Appendix A1 – Respondent: NT Depart of  
Attorney General and Justice (NT Work Safe)

**From:** [REDACTED]  
**Sent:** Wednesday, 3 May 2017 8:25 AM  
**To:** eia NTEPA  
**Cc:** [REDACTED]  
**Subject:** HPRM: RE: For Comment: Draft EIS - McArthur River Mining - Overburden Management Project

Appendix A2 – Respondent: NT Depart of  
Tourism & Culture – Heritage Branch

Figure 10: Conceptual representation of the McArthur River site after the end of mining

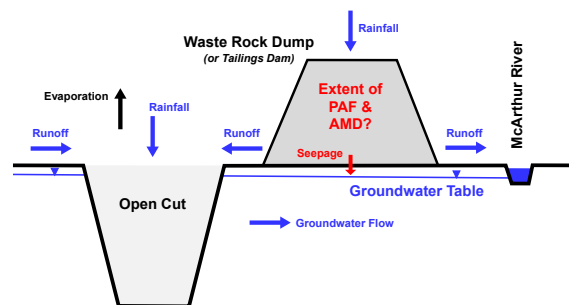
waste rock dumps and tailings dams will be covered and rehabilitated as they are (i.e. above ground), this is without doubt unsustainable unless there is acceptance of active management of the site in perpetuity. In other words, the site would need constant monitoring and maintenance to manage AMD risks and ensure protection of the McArthur River itself and the ecosystems and communities that depend on it. From Figure 10, this means that all runoff would need to be tested and managed according to the extent of AMD it contains, including booth surface water runoff and any seepage to groundwater also.

At present, it is critical to understand and assess these contrasting end-of-mine scenarios—rehabilitating waste rock dumps and tailings dams above ground (aka Figure 10), or backfilling PAF wastes into the open cut and covering with NAF wastes (aka Figures 11 and 12)—to allow informed decision making on both short and long-term risks, especially AMD generation rates and likely impacts, with the expected costs and benefits of each scenario.

Figure 11: Conceptual representation of the McArthur River site after the end of mining assuming PAF wastes are smaller in volume than NAF wastes and PAF wastes are buried deep in the former open cut

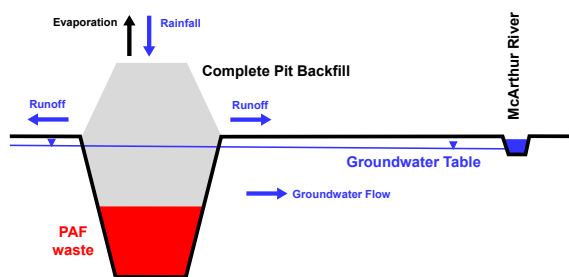
An alternative approach is to relocate all PAF materials to the open cut after mining ceases, and then place NAF material over the top, as shown below in Figure 11. This figure, somewhat optimistically, assumes that the life-of-mine waste balance suggests that there is much greater NAF than PAF wastes—and with the PAF material buried deeper in the pit, this would ensure that these sulfidic wastes are below the re-established groundwater table and therefore minimal oxygen is present to drive AMD generation. Although there may still be risks of impacts on the surrounding groundwater quality, this would, conceptually at the very least, appear to be considerably lower than the Figure 10 scenario of leaving PAF wastes above ground and subject to erosion, infiltration and—in the end—extreme AMD risks for the long-term (probably many decades or longer).

Figure 12: Conceptual representation of the McArthur River site after the end of mining assuming PAF wastes are greater in volume than NAF wastes and PAF wastes are buried deep in the former open cut but still approach the ground surface

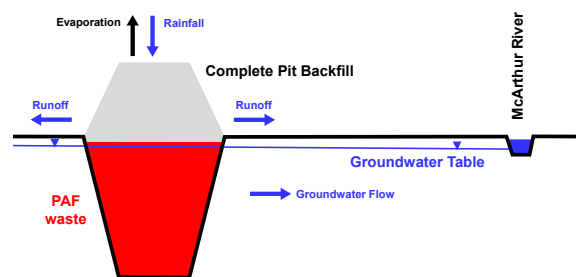
The more realistic scenario, however, is that the PAF materials will be significantly greater in volume than NAF materials that they reach towards the top of the pit and potentially even remain above the re-established groundwater table after mining, as shown in Figure 12. The vast majority of the PAF wastes would be below the water table and present minimal AMD risk, a small

quantity would remain above the water table and exposed to fluctuating infiltration and oxygen ingress given the wet-dry tropical climate of the region—leading to some AMD generation, which would seep into the deeper wastes within the pit and create potential to flow downgradient into the surrounding groundwater system. In reality, this is a very complex situation to assess, and given the paucity of data publicly available at present, it remains uncertain as to how realistic this scenario is for the life-of-mine plan for the McArthur River project. There may be technical or engineering options available to address such risks, such as grout curtains around the pit to limit outwards flow, reactive permeable walls made of say finely crushed limestone or other acid-neutralising materials, red mud from bauxite refining, or other approaches often used in contaminated site and AMD remediation projects (there is a wide array of literature on such methods, but this is beyond the scope available for this report).
